**OHIO TURNPIKE AND  
INFRASTRUCTURE COMMISSION**

**ADDENDUM NO. 1**

**PROJECT NO. 70-19-01  
M.P. 222.0 EASTBOUND SLOPE REPAIR  
M.P. 222.5 EASTBOUND DITCH REPAIR  
MILEPOST 222.0 AND MILEPOST 222.5  
WEST AUSTINTOWN, MAHONING COUNTY, OHIO**

C:\Ohio Turnpike Comm\112148A.00 - 2016 GES Design Contract\Task 10 MP 222.5 EB Slip Rpt\148-10\roadway\sheet\71-19-05\_G7001.dwg: Title Sheet: 3/19/19 - 4:50pm

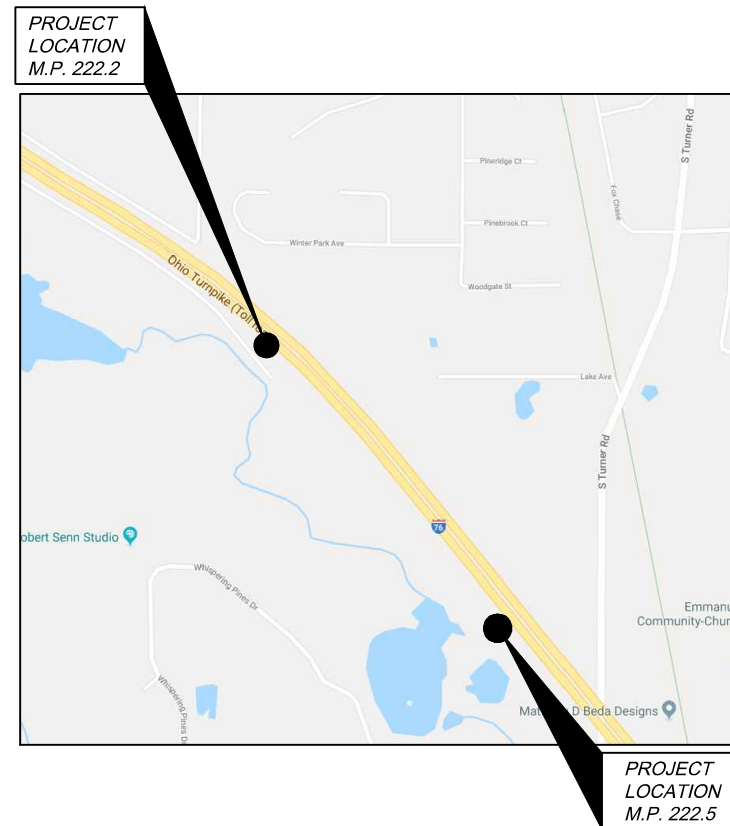
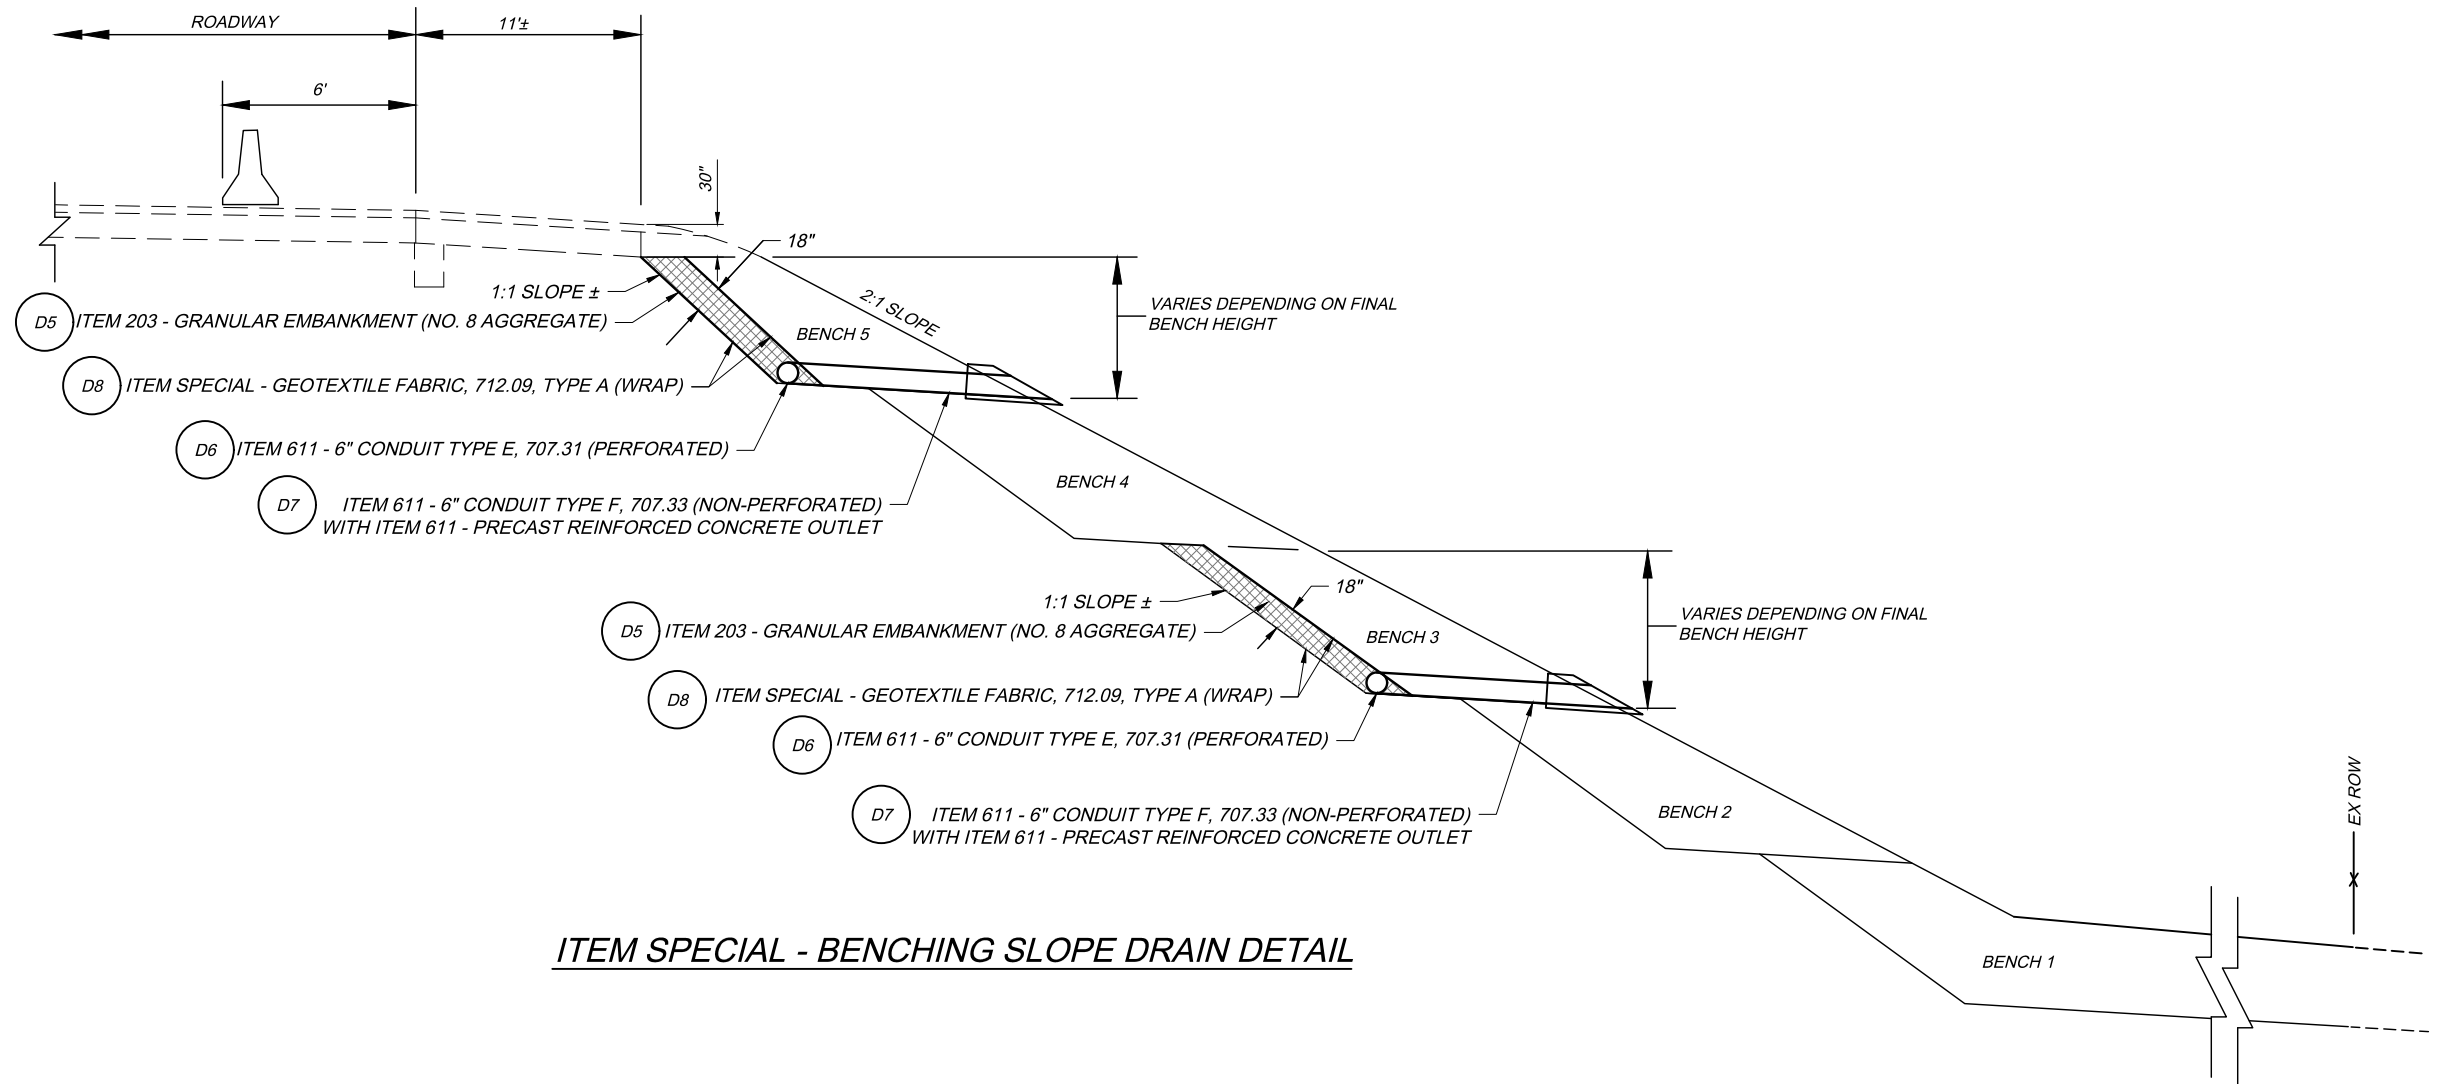
**Q#3 The bid quantity for Ref. No. 33 Item 832 is 1 EACH. Per 832 and the ADDITIONAL CONTROLS note on the plan cover page, this would amount to a lump sum total of \$1.00. Please clarify the Commission's intent with respect to this item.**

*A#3 Bid Schedule of Items, the Estimate Quantities Worksheet and Plan Sheet Nos. 1 and 7 of 7 are modified through this Addendum No. 1 to add an additional note for clarification and to revise the plan quantity for Reference No. 33, Item 832 from 1 to 10,000.*

ANY ADDITIONAL SEDIMENT AND EROSION CONTROLS REQUIRED TO MANAGE SEDIMENT AND EROSION FOR THIS PROJECT, NOT SEPARATELY ITEMIZED HERE IN, AND REQUIRED IN THE STORM WATER POLLUTION PREVENTION PLAN (SWP3) AND /OR REQUIRED AS PART OF SUPPLEMENTAL SPECIFICATION 832 SHALL BE PAID FOR AT THE UNIT BID PRICE FOR ITEM 832 - EROSION CONTROL.
